**WILLIAM STATES LEE III
 NUCLEAR STATION UNITS 1 & 2**

Attachment 4

Revisions to FSAR Chapter 2, Subsection 2.5.5

WILLIAM STATES LEE III
 NUCLEAR STATION UNITS 1 & 2
 Planned Excavation Profile
 Geologic Cross Section F-F'
 FIGURE 2.5.4-263

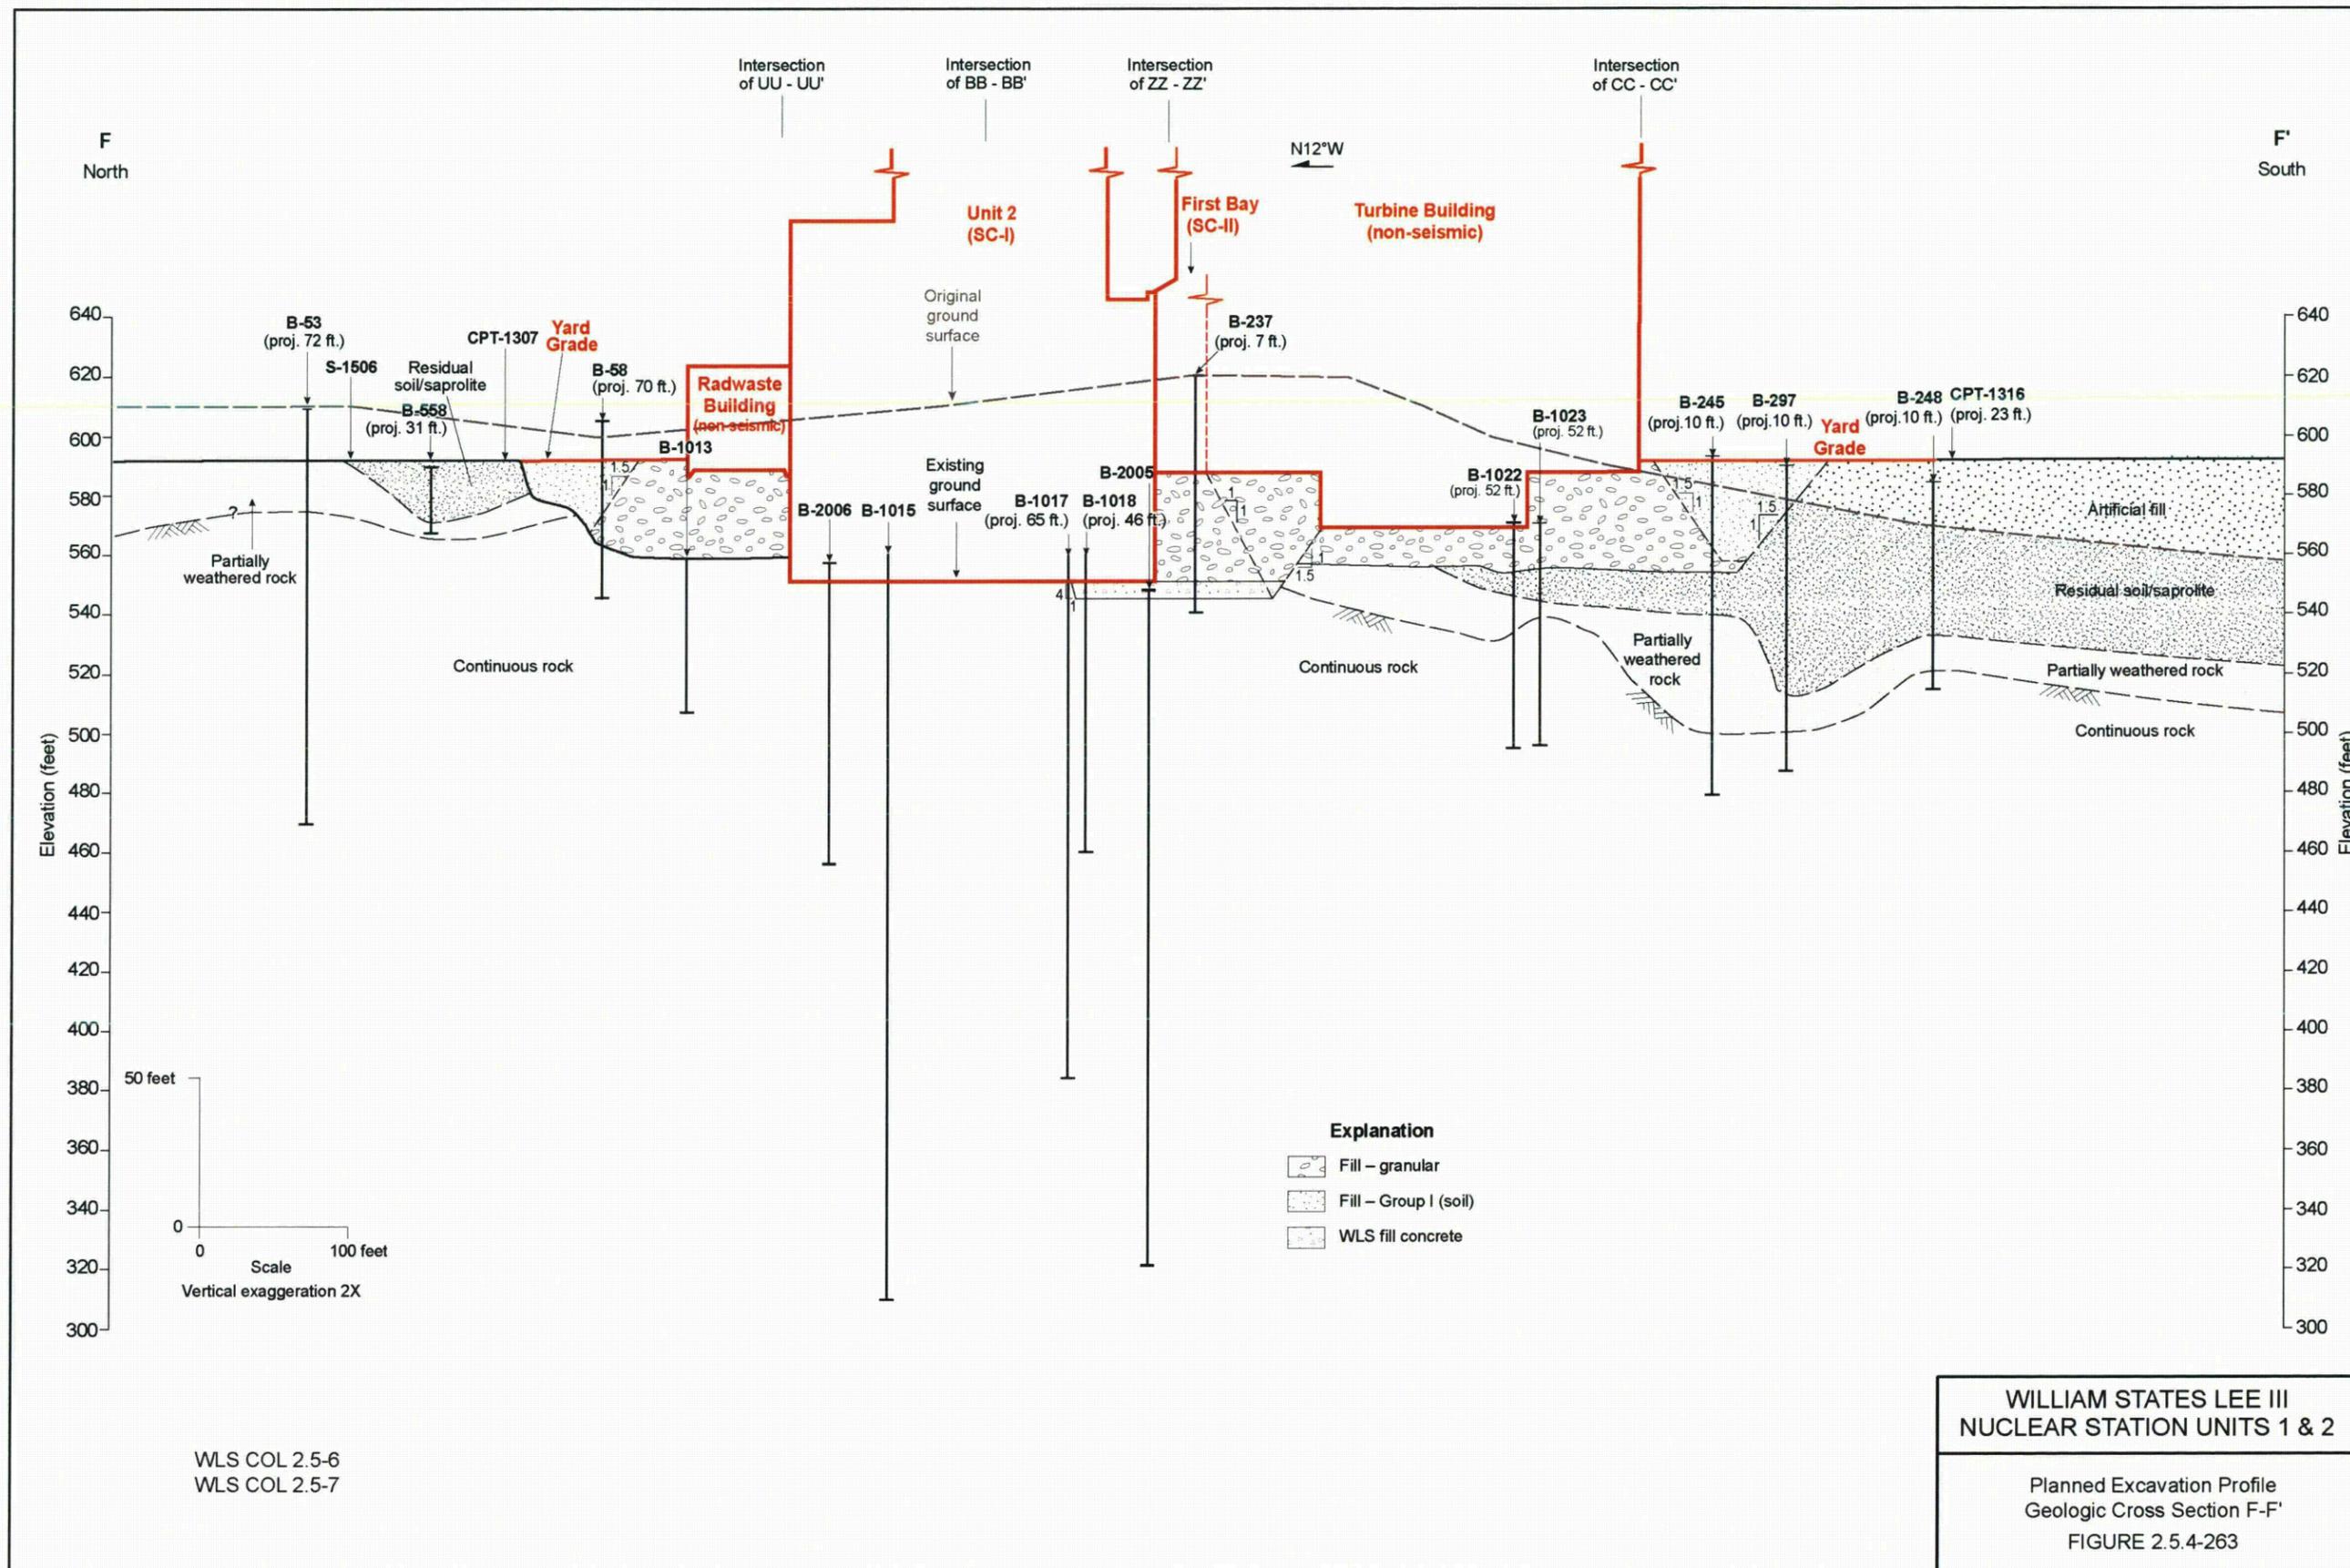
142. COLA Part 2, FSAR Chapter 2, Figure 2.5.4-263 is revised as follows:

FIGURE 2.5.4-266

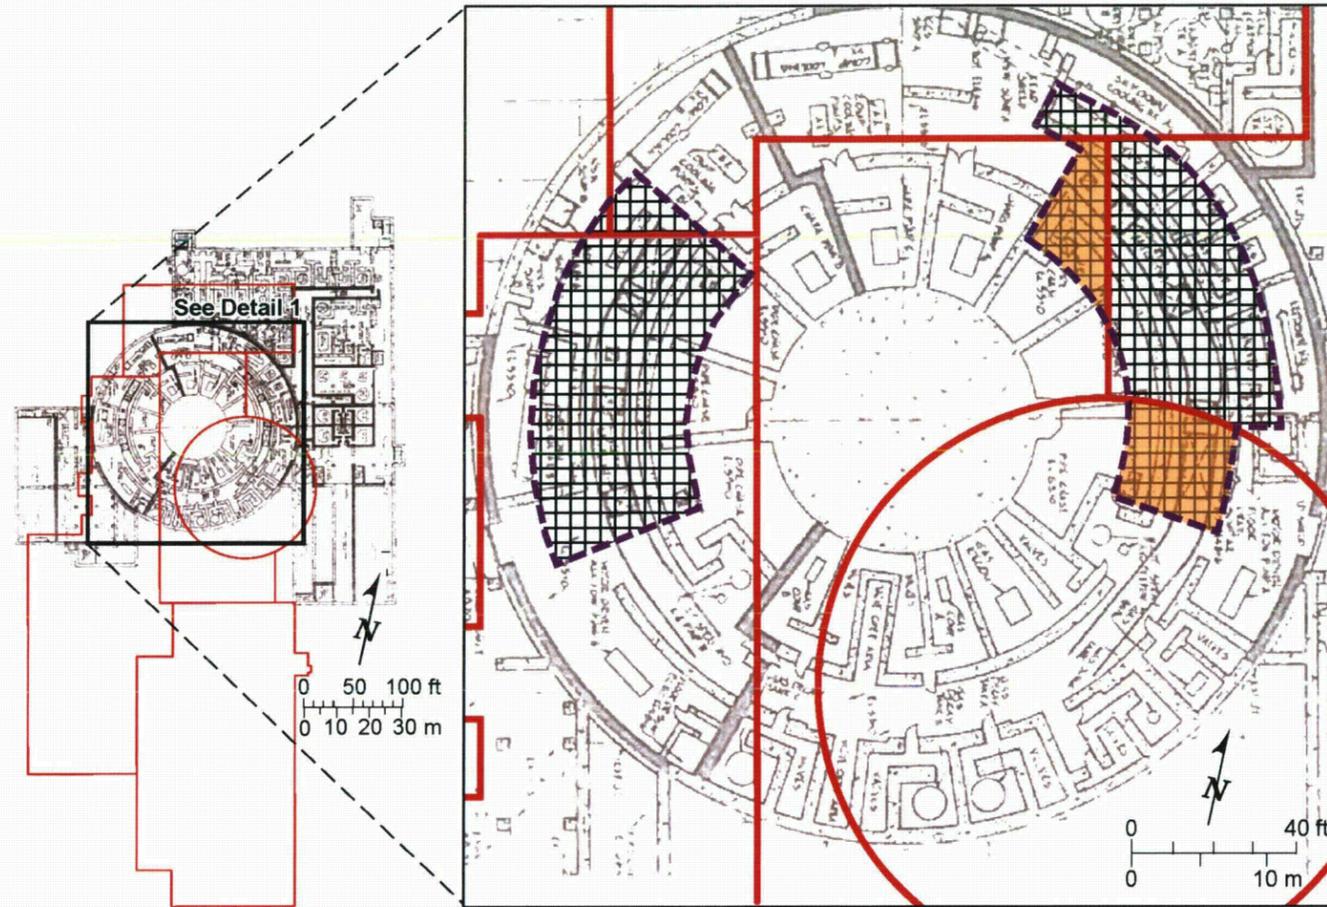
145. COLA Part 2, FSAR Chapter 2, Figure 2.5.4-266 is added as follows:

FIGURE 3.7-202

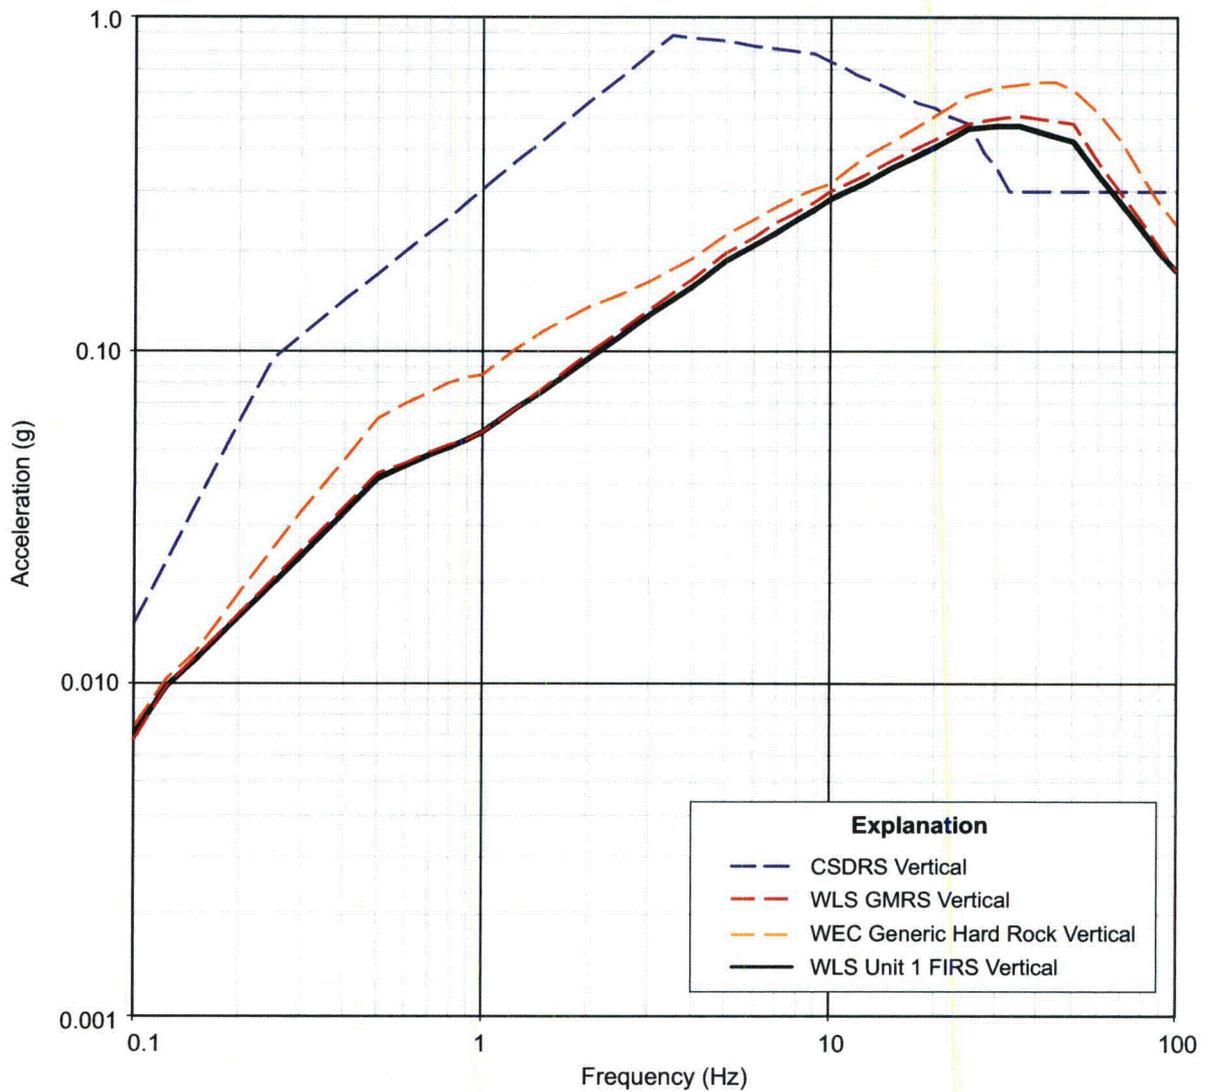
9. COLA Part 2, FSAR Chapter 3, Figure 3.7-202 is revised as follows:

FIGURE 3.7-203

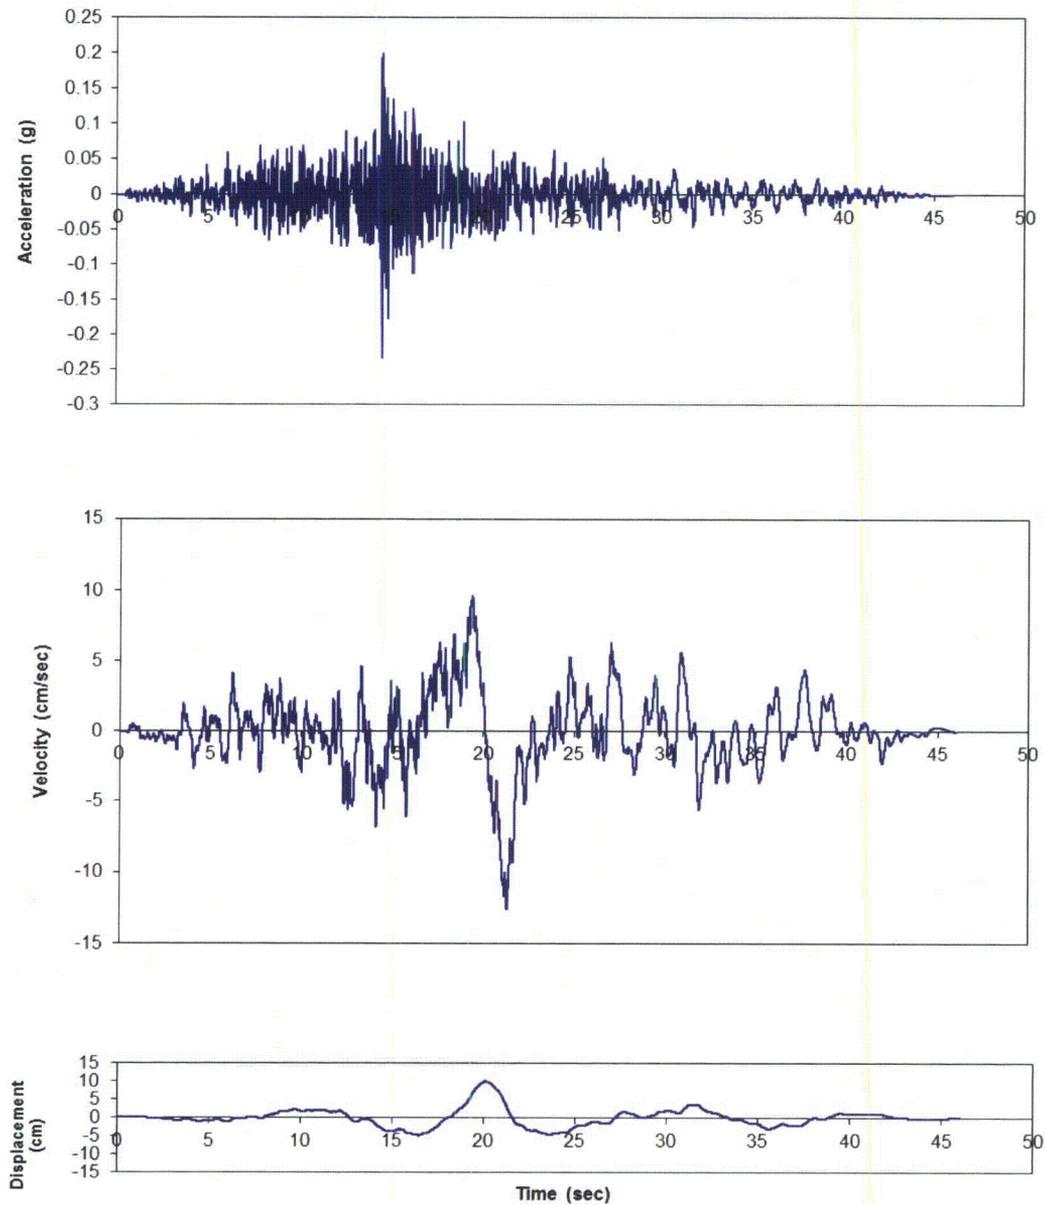
Attributes of the resulting time histories representing the Unit 1 FIRS are shown in FSAR Table 3.7-201. FSAR Figure 3.7-203 illustrates a representative horizontal component time history.

10. COLA Part 2, FSAR Chapter 3, Figure 3.7-203 is revised as follows:
